Project	IEEE 802.16 Broadband Wireless Access Working Group < http://ieee802.org/16 >	
Title	Clarification of HARQ data region and consistence of protocol in HARQ format configuration	
Date Submitted	2005-01-10	
Source(s)	Meng Zhao Dongyan Bi ZTE Corporation Address	Voice: Fax: E-mail:
Re:	Response to Sponsor Ballot on IEEE802.16e/D5a document	
Abstract	Because the HARQ data transmission is relatively independent to other data transmissions, it is need to set clear position of HARQ data region. At the same time to obtain consistence to the addition of HARQ in MIMO mode some HARQ-IE must be revised to adapt these changes.	
Purpose	To incorporate the text changes proposed in this contribution into the 802.16e/D6 draft.	
Notice	This document has been prepared to assist IEEE 802.16. It is offered as a basis for discussion and is not binding on the contributing individual(s) or organization(s). The material in this document is subject to change in form and content after further study. The contributor(s) reserve(s) the right to add, amend or withdraw material contained herein.

Clarification of HARQ data region and consistence of protocol in HARQ format configuration

Figure 24—Downlink H-ARQ Sub-frame Structure

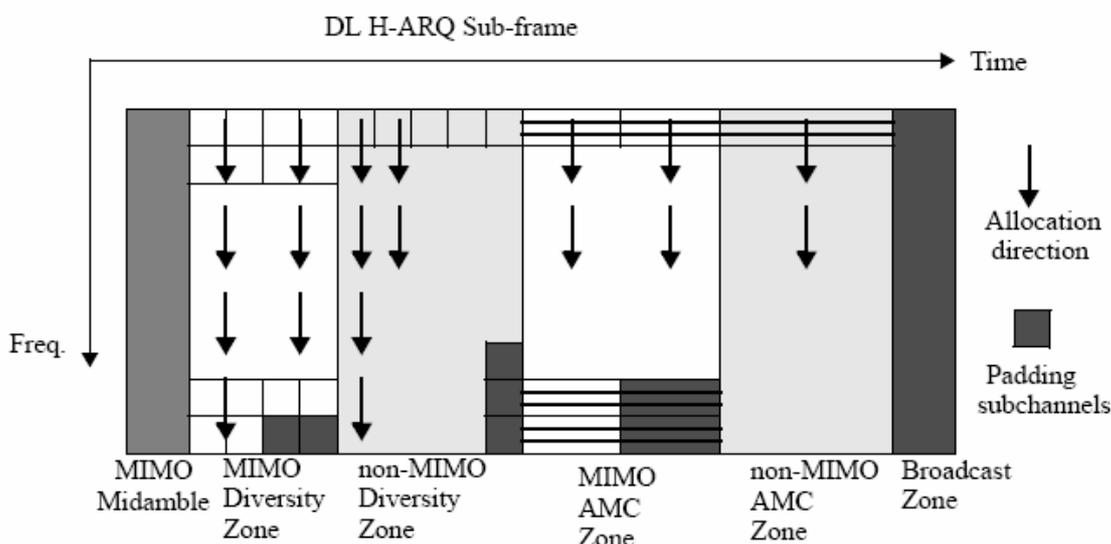
In protocol figure 24 indicate one instance of DL HARQ sub-frame. But in the compact DL-MAP IE --Format configuration IE, which only provide the position of broadcast and band AMC. So we must set the position for MIMO.

In normal DL-MAP there is no clear definition of HARQ data region. We add the description of HARQ data sub-frame in H-ARQ MAP pointer IE. Because the whole band allocated to the BS could be used, we only need “No. OFDM Symbols” and “OFDMA Symbol offset” to describe the HARQ data sub-frame. In normal UL-MAP there is also no clear definition of

UL HARQ data sub-frame. We add H-ARQ UL-Data Region IE in extended UIUC to describe the location of H-ARQ UL-Data sub-frame. Because the whole band allocated to the BS could be used, we only need “No. OFDM Symbols” and “OFDMA Symbol offset ” to describe the HARQ data sub-frame.

Then we allocate some region of the whole HARQ data sub-frame to each mode supported in Format configuration IE. But in Format configuration IE of HARQ compact DL-MAP IE there are only OFDM numbers of AMC mode. It is necessary to add the number of symbols of MIMO mode in this IE. Because there are several modes supported, we introduce Mode Support Index to denote which modes must be supported in the current frame or following frames. The index would save the spending if some modes are not supported, that is, if some modes are not supported we won't set the OFDM numbers for this mode. In general, the normal mode (non-MIMO diversity zone) should be included, which we won't indicate it's existing in Mode Support Index. So there are about eight modes to be indicated:
